Zoning Board of Appeals

Zoning Board of Appeals Staff Report

SUBJECT: ZBA #24-03-03: 825 and 847 Portage Street / 720 and 726 E. Vine Street. The Boys and Girls Club of Kalamazoo is requesting the following:

PROPOSED LEGEND

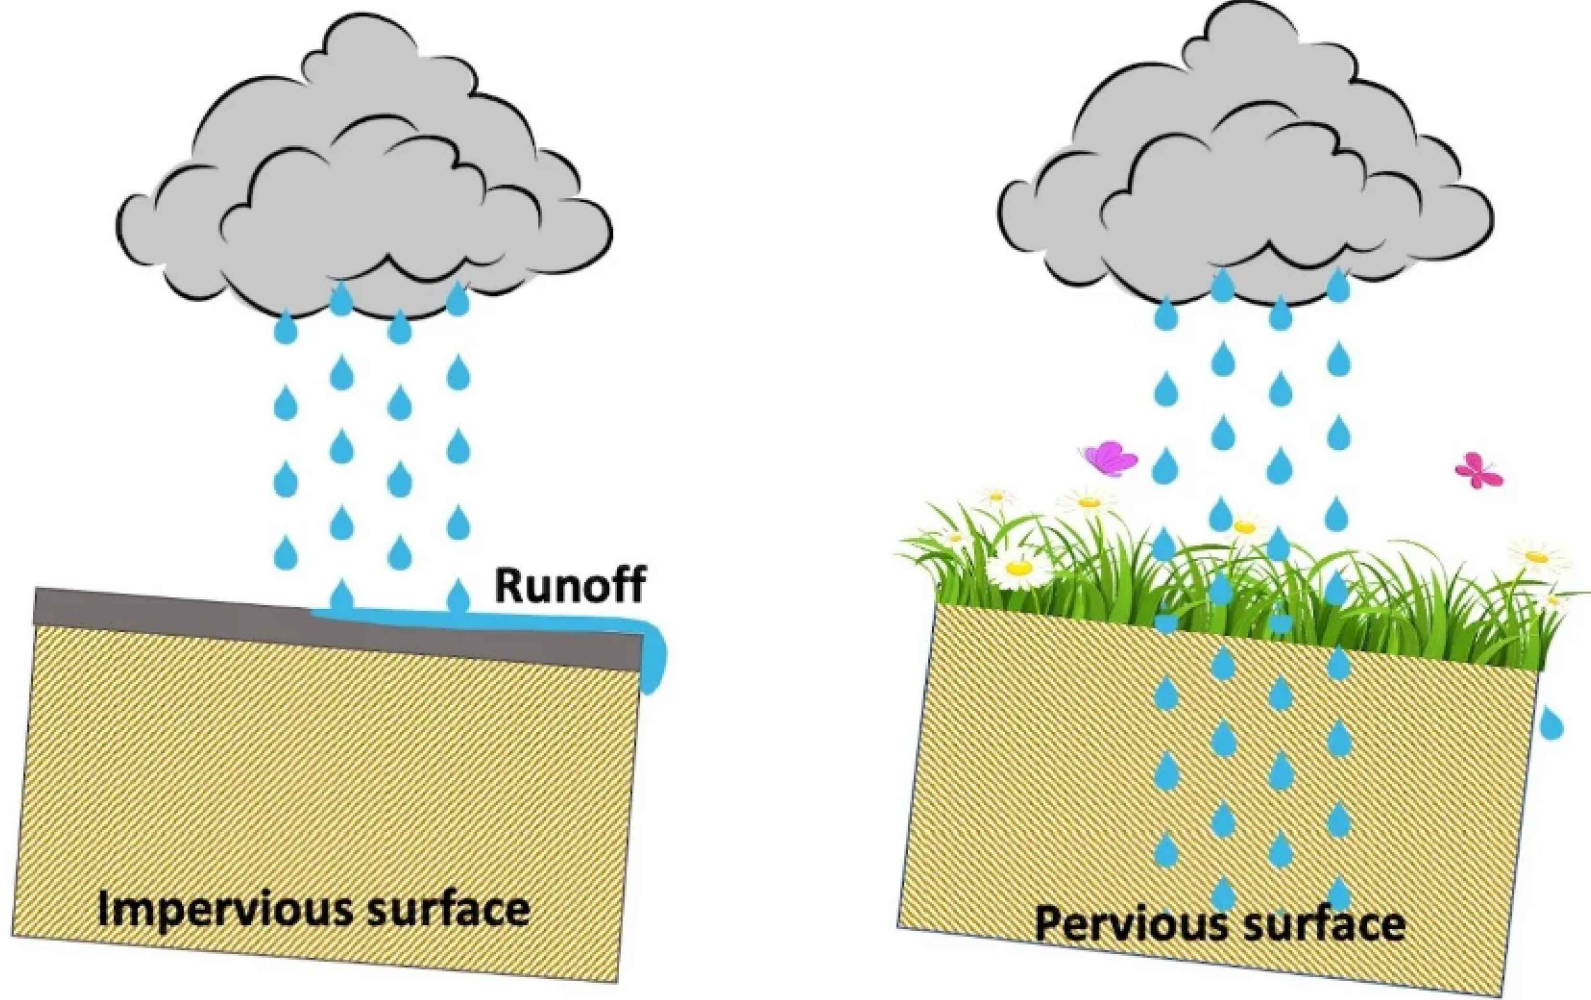
**Impervious Surface Coverage - There are two unique conditions to be considered.
The shape of the lot is unique due to the angle of Portage Street. This means the**

parking lot is also a unique shape that results in more areas of paving than if the lot was a rectangle. Also, this property has known soil contamination, which impacts the design of the site.

Impervious Surface Coverage - Between the 1930s and 1950s, the Portage Street frontage contained a gas station and automotive service center. There was also a dry cleaner on the premises sometime between the 1950s and 1970s. As a result of these previous occupants, the site has contamination; this contamination is not a result of an action by the applicant. Allowing for additional impervious cover will reduce the site's potential for infiltration (absorption) of stormwater through contaminated soil, and thereby reduce groundwater contamination.

Impervious Surface Coverage - The application of the ordinance provisions would require the applicant to have additional pervious surface area. A reduction in the pervious surface on this contaminated site could lead to reduced infiltration of stormwater and a potential reduced risk of groundwater pollution.

Impervious Surface Coverage - This is the minimum action that will allow for the parking lot to meet all codes for drive aisle width and parking space dimensions.

Impervious Surface Coverage - The granting of the variance will not adversely impact adjacent property. Allowing for increased impervious cover will reduce the infiltration of water into the ground and reduce the migration of contaminated groundwater to adjacent properties.

Impervious Surface Coverage - This is consistent with the purpose and intent of the ordinance. Where normally compliance with the impervious coverage is supported, this site is not an ideal candidate for water infiltration due to soil and groundwater contamination.

Staff does not recommend the approval of the front facade entrance variance as it does not meet any of the review criteria. Staff recommends approval of the impervious coverage variance as it meets all of the review criteria.

A SOUTH ELEVATION
1/8" = 1'-0"

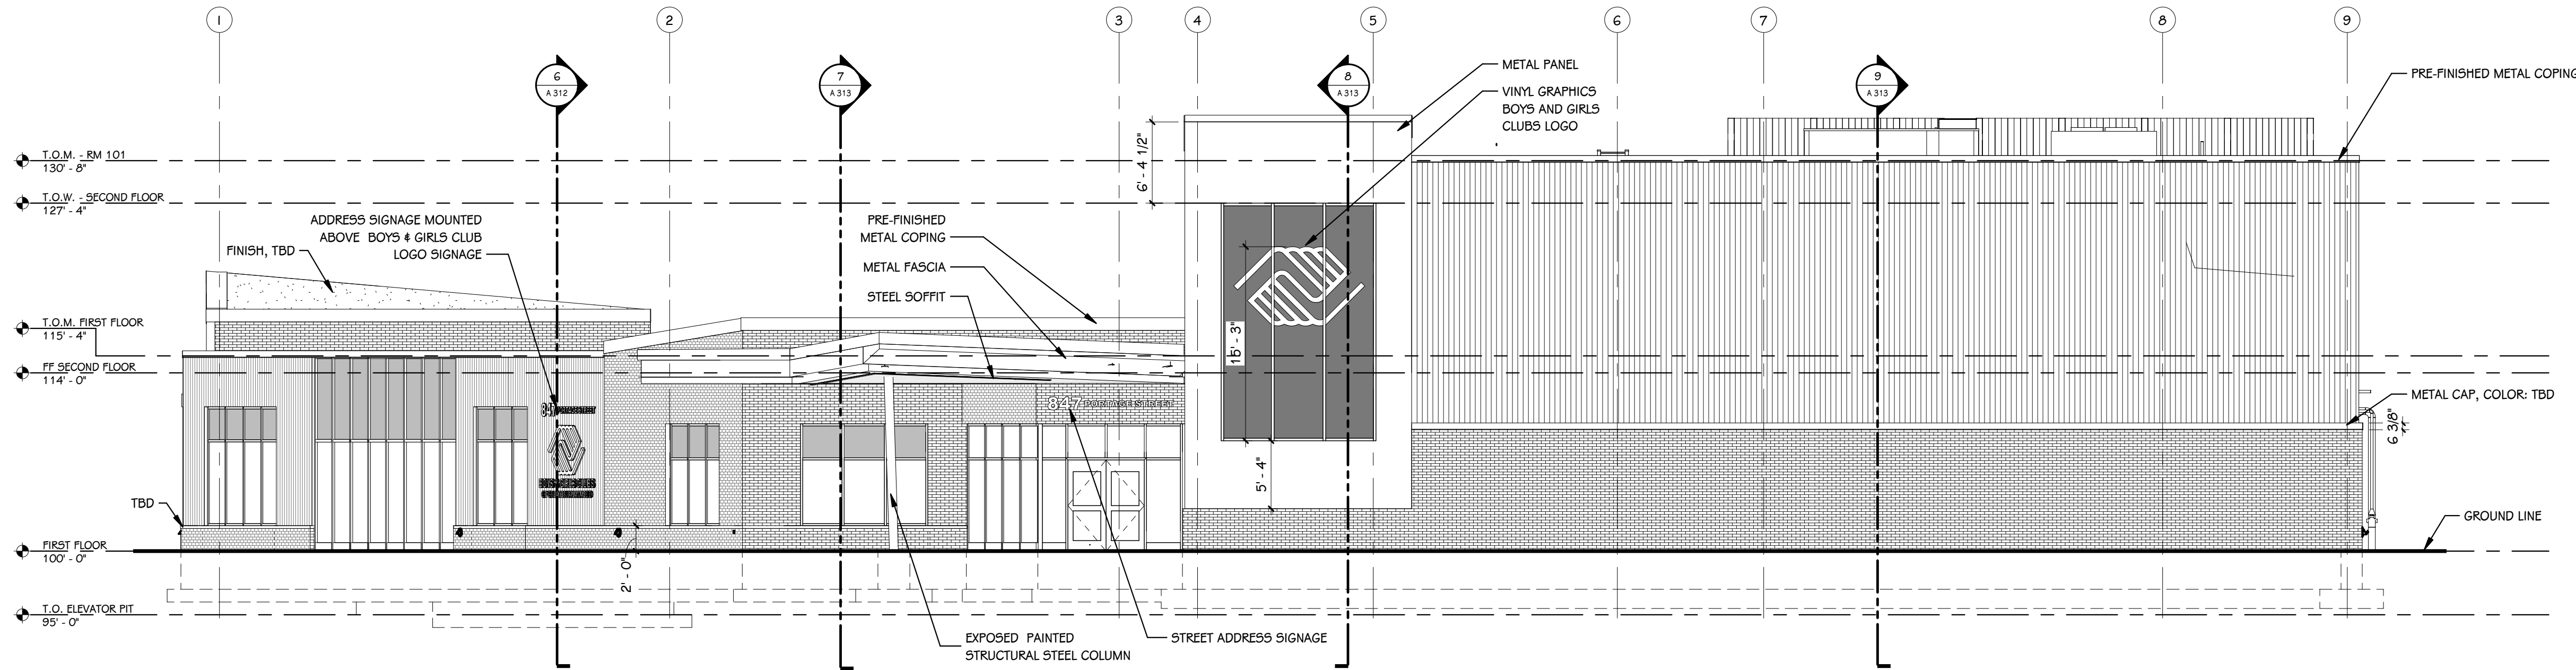
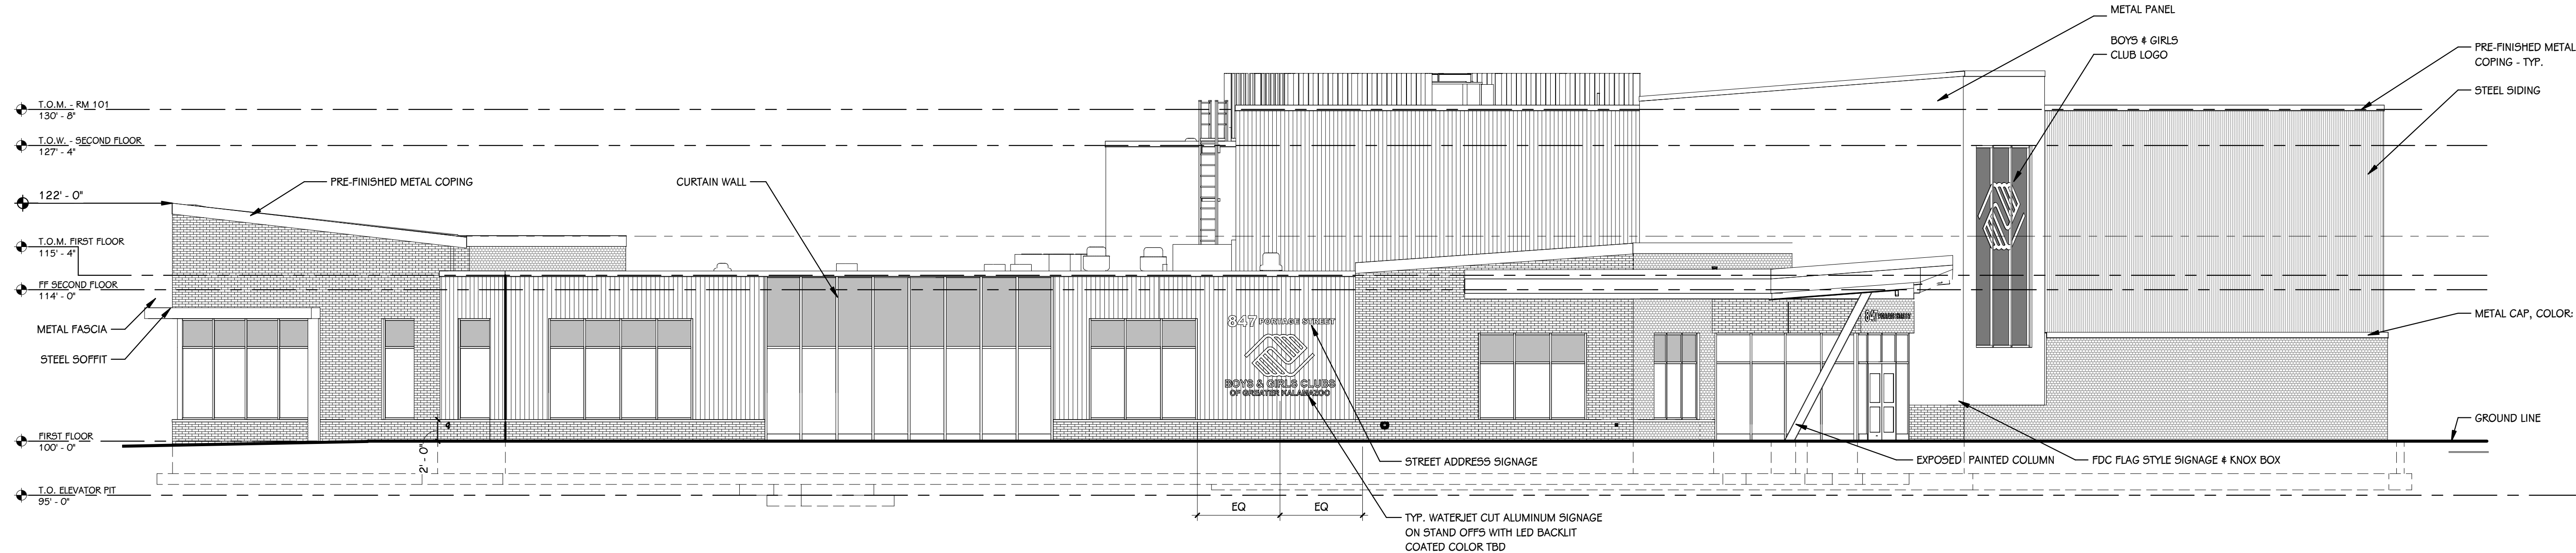
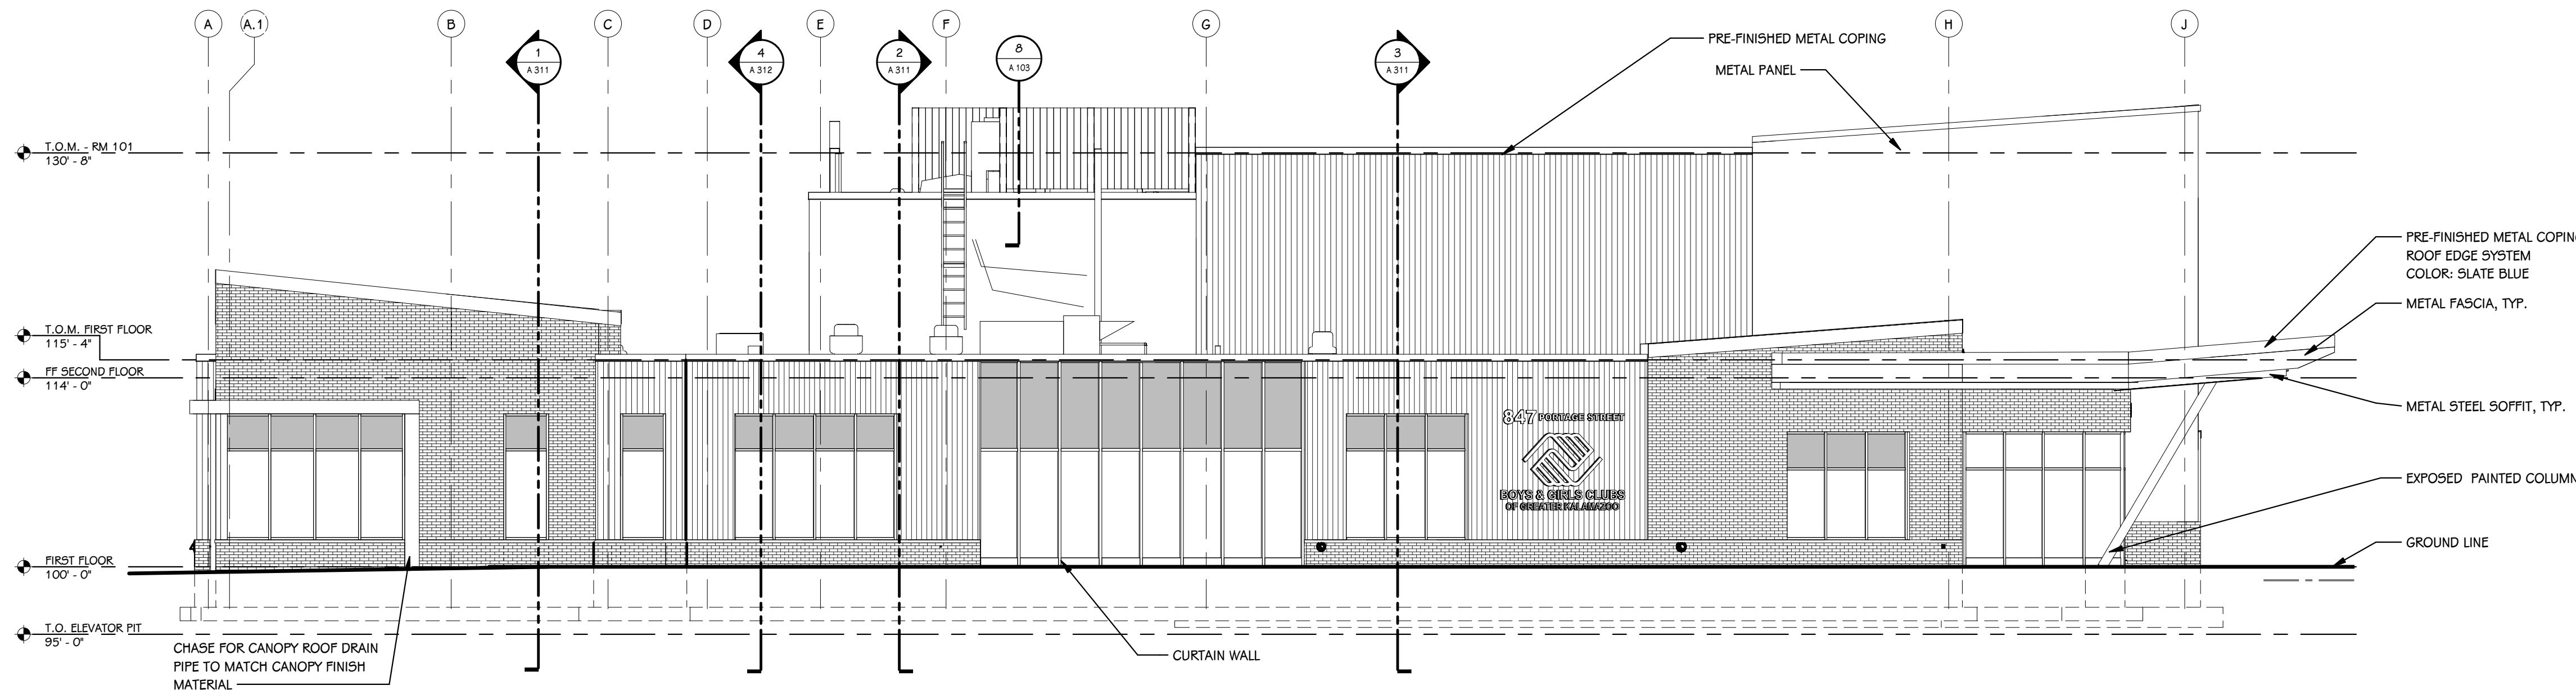
Entrances - There are no special circumstances that impact the number of entrances of a building constructed on this lot.

Entrances - There are not property-specific special circumstances supporting this request. The request is the result of the applicant opting not to include two entrances on Portage Street. The applicant has cited safety concerns, but staff cannot substantiate this concern since the applicant elected to locate this use (youth center) at this location.

Entrances - The requirement to locate entrances on the front facade in a quantity based on the length of the building is the same standard that is applied to every other property between Downtown and Washington Square. New buildings are required to meet the zoning ordinance, including the entrance requirement. The literal interpretation of the ordinance does not deprive the applicant of rights enjoyed by others in the same zoning district, which was created to support active corridors like Portage Street,

Entrances - The granting of the variance is contrary to the spirit and intent of the ordinance to support an active, vibrant mixed-use area. Other commercial districts, such as Community Commercial and Community Commercial 2, do not have the same requirements for the building facades. These districts are *not located* on our urban active corridors, such as Portage Street. They are located in higher speed, wider lanes, or auto-oriented areas. This property was intentionally zoned with a Live Work District that included transparency and entrance requirements because new buildings are intended to support the easily accessible, active corridor linking Downtown with Washington Square.

Entrance - The granting of the variance could adversely impact adjacent properties, the vision of the Edison Neighborhood Plan and Master Plan for an active, multi-modal Portage Street corridor. Approving this variance could set a precedent for other new buildings to make the same request. In order to create the active, welcoming, vibrant place envisioned by the community, both the street and the private development must each play a role. The building's role is to be located close to the sidewalk and have transparency and entrances to create interesting, welcoming, and easily accessible spaces.

Entrances - As stated with criteria 5 above, the granting of this variance would not be consistent with the purpose and intent of the ordinance and area plans.
